# Technical Bulletin

## REQUIRED VEHICLE UPDATE TECHNICAL BULLETIN (RVUTB)

20 08 03 Jul. 17, 2008 2018345 **Supersedes RVUTB 20 08 02 dated July 16, 2008 due to REVISED SAGA Claiming Instructions**

### RVU – Fuel Pressure Sensor Replacement (SAGA Code 24M5/O5)

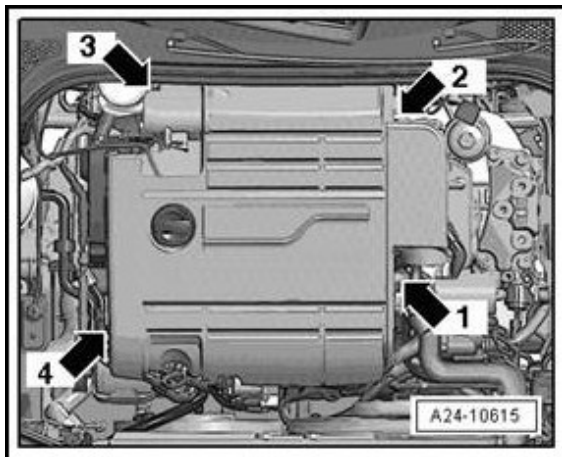
To prevent damage to engine cover, engine cover stops must be removed in the sequence as shown.
